Bid Bulletin #03

PROJECT: Weeping Water Public Schools
Additions & Renovations
Weeping Water, NE

RE: Addendum No. 2 to the Bidding Documents for:
Weeping Water Public Schools
Additions & Renovation
204 West O Street
Weeping Water, Nebraska 68463
Schemmer Project No. 06368.001

This addendum consists of nine 9 pages of written addendum items and thirty-three 33 pages of supplemental drawings.

SHEET NO: SDM-12

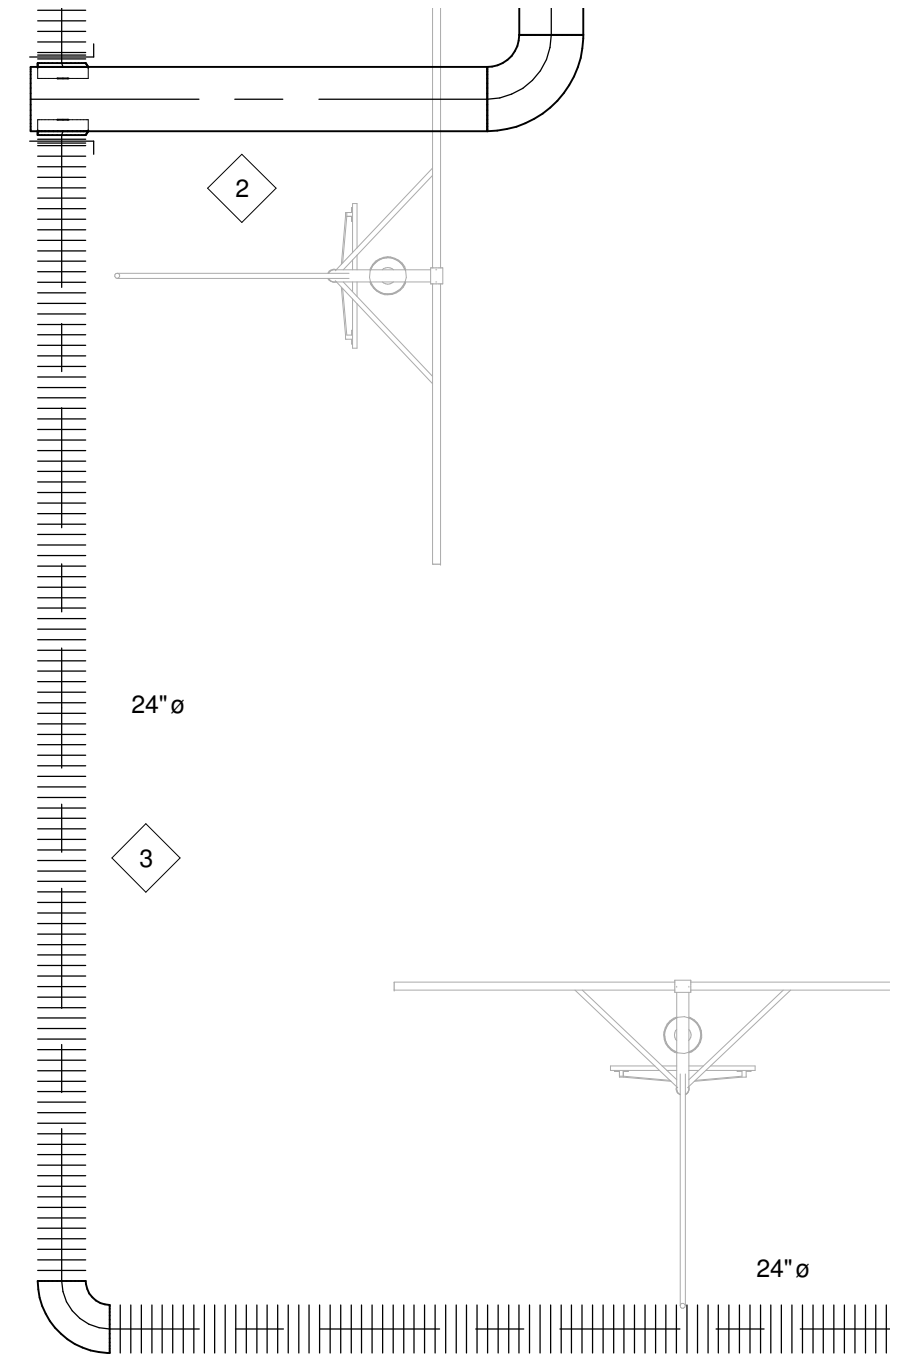
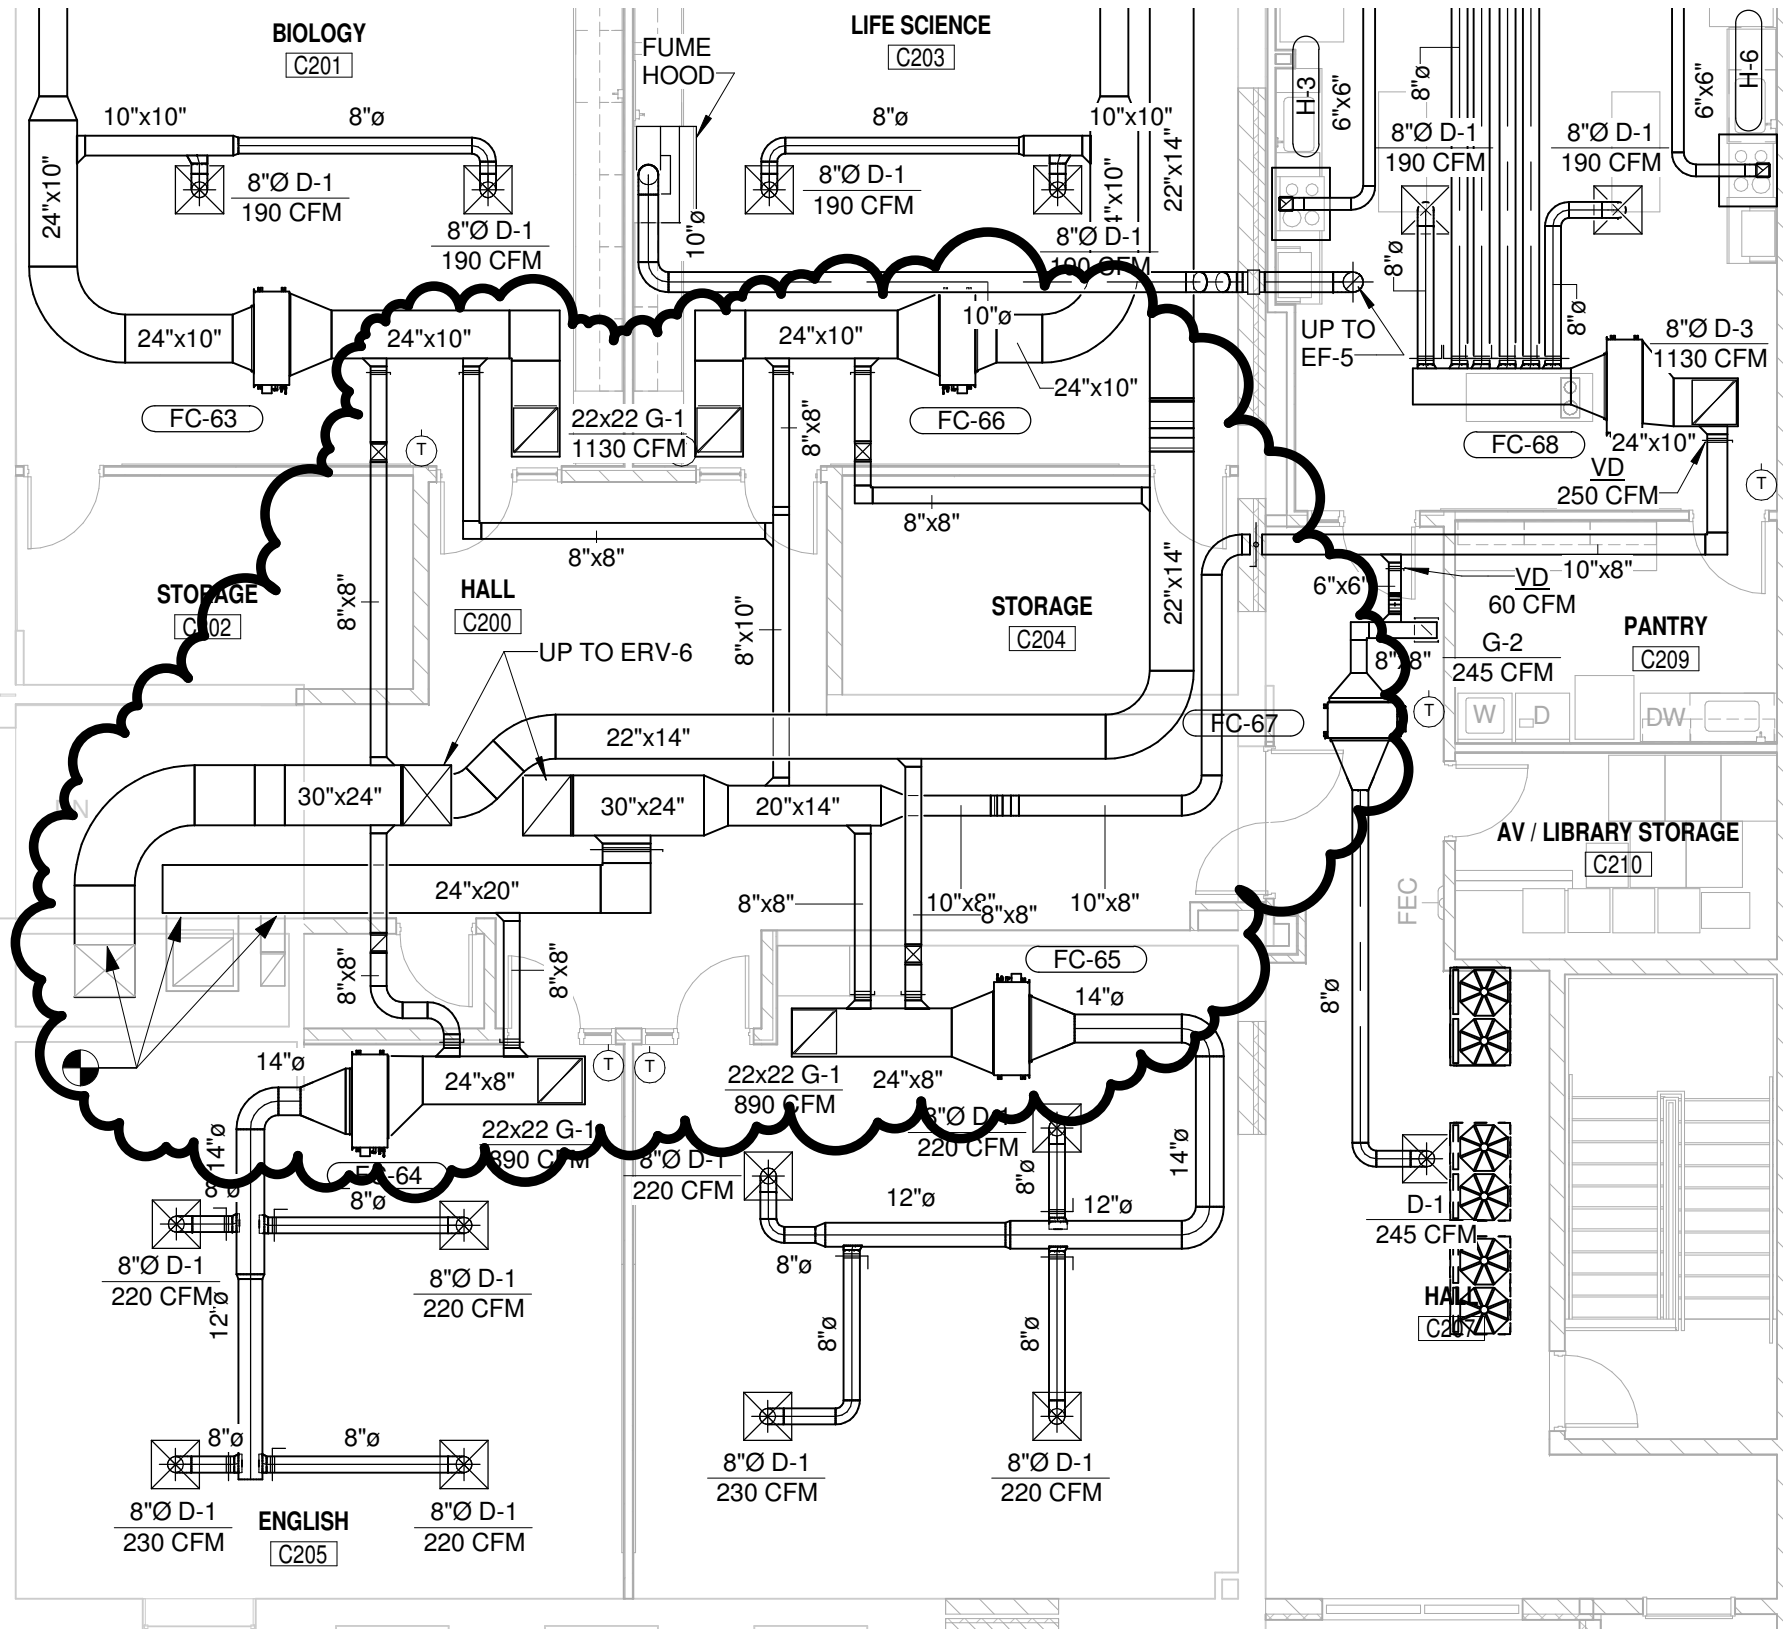
Item No. DM-9, Sheet M1-08

- 1) See supplemental drawings SDM-11 and SDM-12 for added content to this sheet.

SHEET NO: SDP-1

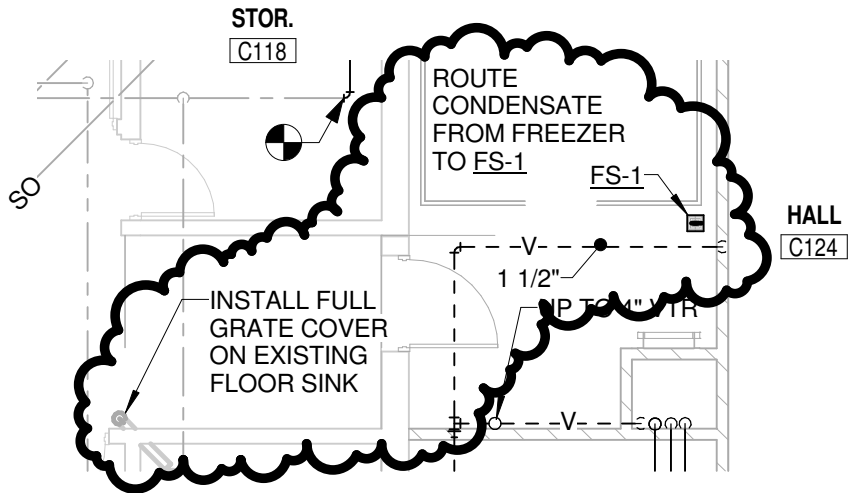
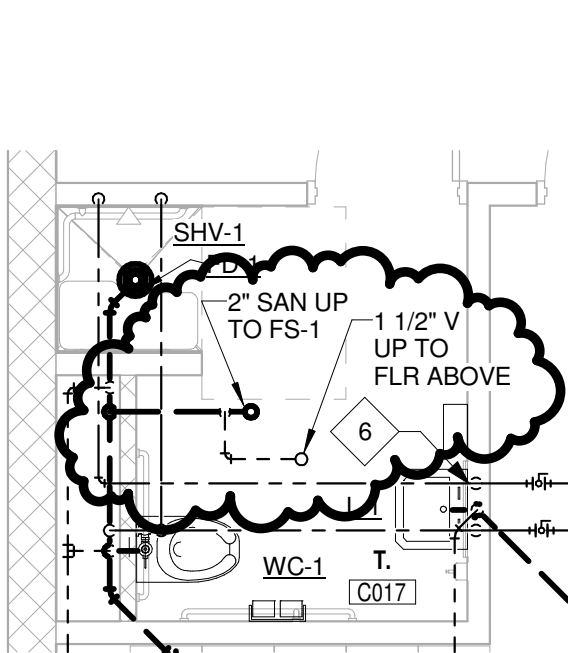
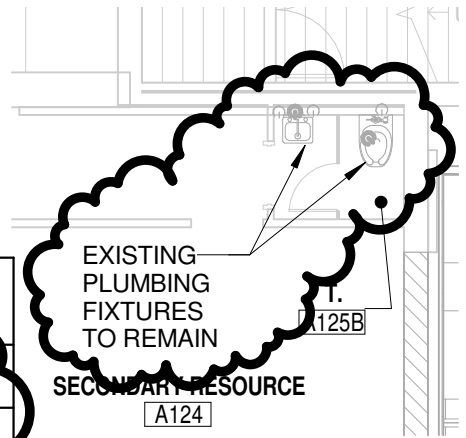
Item No. DM-2, Sheet P1-04, P1-06, P1-10, P4-01.

- 1) See supplemental drawing SDP-1 for plumbing revisions.

SHEET NO: SDP-2

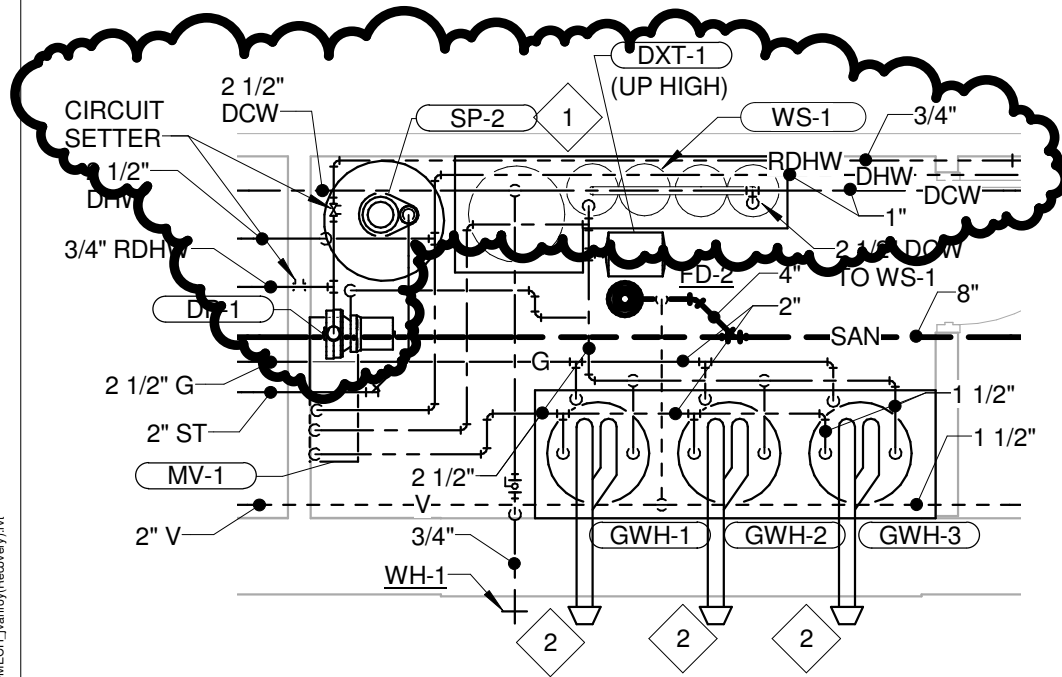
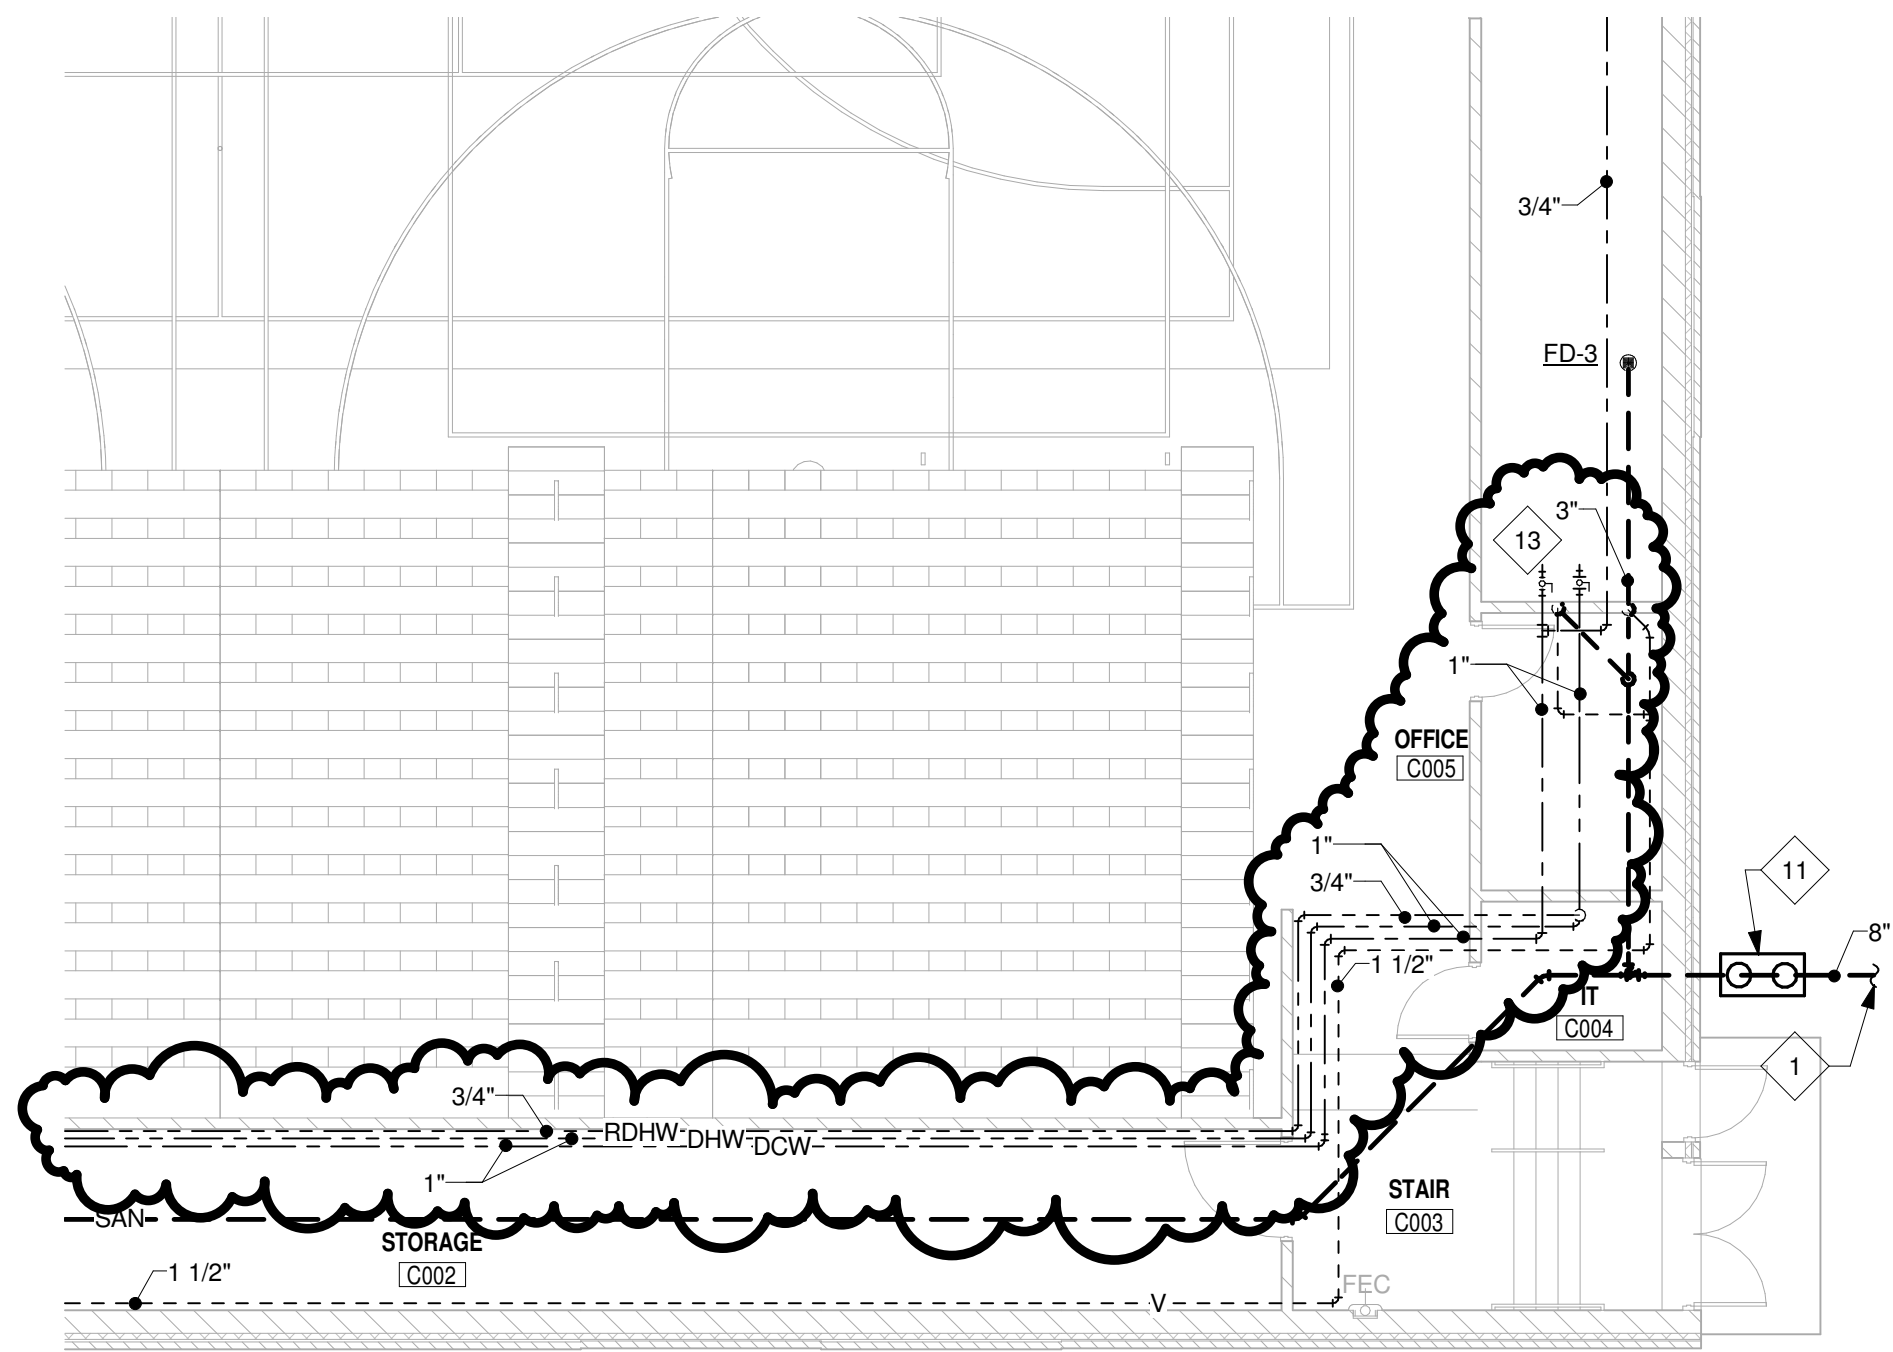
Item No. DM-11, Sheet P1-03 and P1-10

- 1) Domestic cold water, hot water and recirculating hot water extended to north wall of Office C005 and rough-in of utilities for future training room plumbing fixtures. See supplemental drawing SDP-2.

DATE: 02/07/14	DRAWN: LRW	SCALE: 1/8" = 1'-0"	SHEET NO: SDP-3
SHEET TITLE: PLUMBING REVISIONS			REF: 1/P1-09

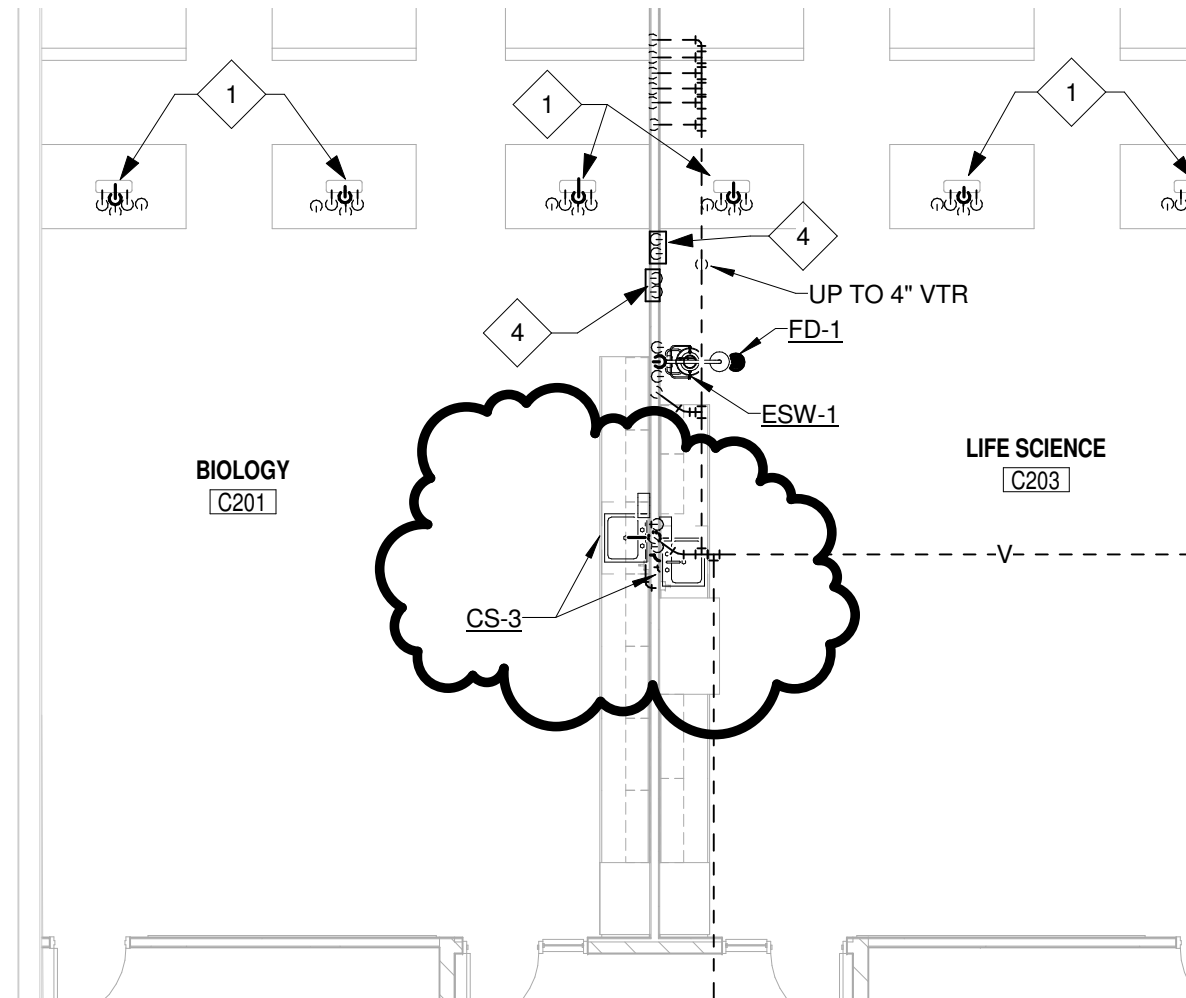
Item No. DM-12, Sheet P1-09

- 1) Provide CS-3 for the two sinks as indicated on SDP-3. Sink basin to be epoxy resin type provided with the countertop, see item DA-8.

SHEET NO: SDE-12

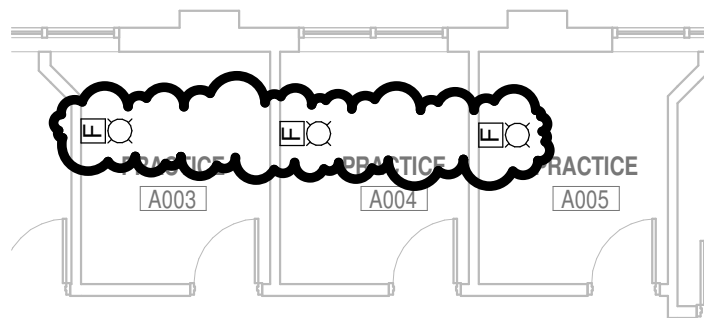
Item No. DE-2, Sheet E3-01.

- 2) See attached SDE-12 for electrical revisions.
